DART AEROSPACE LTD	Work Order: 89883
Description: Crosstube Assembly (206L High Fwd)	Part Number: D206-667-143
Inspection Dwg: D206-667-143 Rev: C	Page 1 of 2

DRAWING NO. D206-667-143	TITLE CROSSTUBE ASS'Y (206L HIGH FWD)	REV. C	DART AEROSPACE LTD ENGINEERING ORDER		D.E.O. NO. D206-667-143-C-1	SHEET NO. SHEET 1 OF 1	SCALE NTS
DRAWN <i>92</i>	CHECKED <i>ASS</i>	MFG. APPR. <i>128</i>	APPROVED <i>MD</i>		DE APPR. <i>MD</i>		
DATE 11.07.15	DATE 11.07.20	DATE 11.07.21	DATE 11/07/21		DATE 11.07.21

DRAWING NO. D206-667-143	TITLE CROSSTUBE ASS'Y (206L HIGH FWD)	REV. C	DART AEROSPACE LTD ENGINEERING ORDER		D.E.O. NO. D206-667-143-C-2	SHEET NO. SHEET 1 OF 1	SCALE NTS
DRAWN AJS	CHECKED	MFG. APPR. <i>E</i>	APPROVED <i>NO</i>	DE APPR. <i>MS</i>			
DATE 12.08.02	DATE 12.08.02	DATE 12.08.02	DATE 12.08.02	DATE 12.08.02

TURNING DETAIL

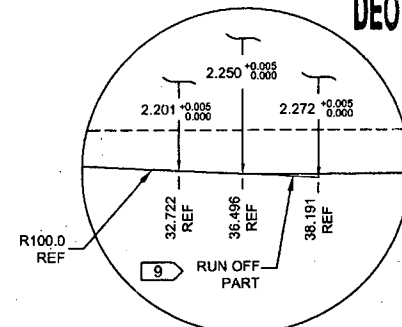
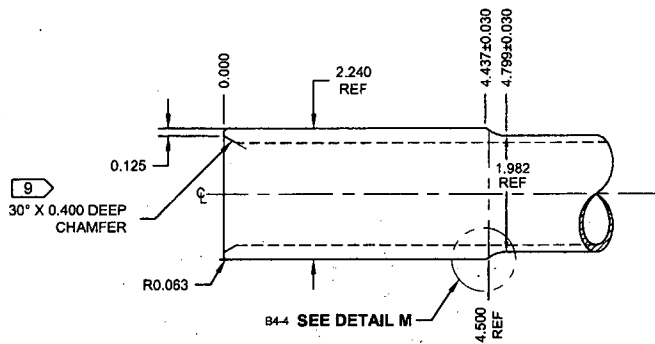
Root Cause	Date	Step	Qty	Description of work order update or Non-conformance	Initial Chief Eng	Action Description	Sign & Date	Verification	QC Inspector		
Doc/Data <input type="checkbox"/>	12/9/26	100	1	Cuffs over tol. ① 2.249" - 2.247" ② 2.248" - 2.248" test offsets not correct. (short too high).	DAS 12 2-23 12/9/26	Saddle fits OK Acceptable	DAS 12 2-23 12/9/26	JW 12-10-2	DAS 16 2-23 12/10/26		
Equip/Tooling <input type="checkbox"/>											
Operator <input type="checkbox"/>											
Material <input checked="" type="checkbox"/>											
Setup <input checked="" type="checkbox"/>											
Other <input type="checkbox"/>											
Process <input type="checkbox"/>											
Supplier <input type="checkbox"/>											
Training <input type="checkbox"/>											
Unapproved <input type="checkbox"/>

DETAIL P
BONDING STRAP INSTALLATION 2 PL

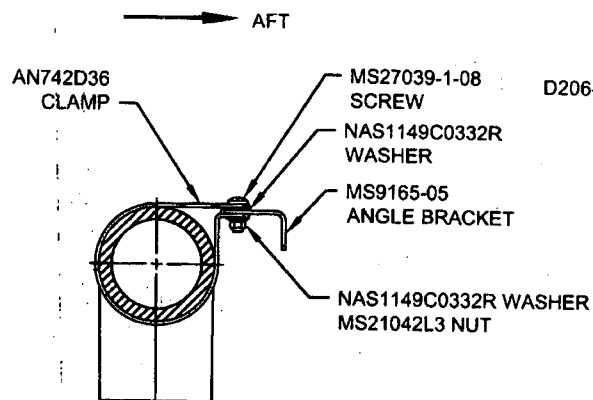
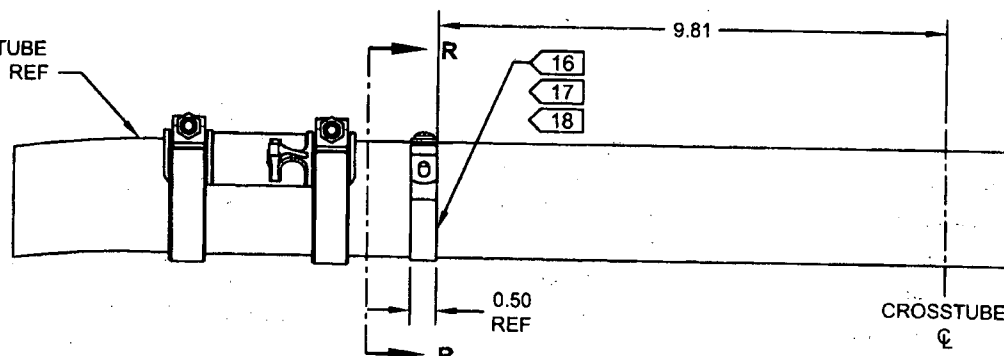
ADD ELECTRICAL GROUNDING STRAP

ITEM	QTY -143	PART NUMBER	DESCRIPTION
1	X	D206-667-143	CROSSTUBE ASSEMBLY (206L HIGH FWD)
⚡			
10	2	AN742D36	CLAMP
11	2	MS9165-05	ANGLE BRACKET
12	2	MS21042L3	NUT (OR MS21042-3)
13	2	MS27039-1-08	SCREW
14	4	NAS1149C0332R	WASHER (OR AN960C10L)

- 16) MASK AREA UNDER CLAMP PRIOR TO PAINTING
- 17) SEAL EDGES WHERE AN742D36 CLAMP MEETS WITH THE CROSSTUBE USING SIKAFLEX-241/-291 OR MIL-S-8802 CLASS B2 OR PROSEAL 890 SEALANT
- 18) PERFORM RESISTANCE CHECK TO ENSURE MAX RESISTANCE IS 10 MILLIOHMS
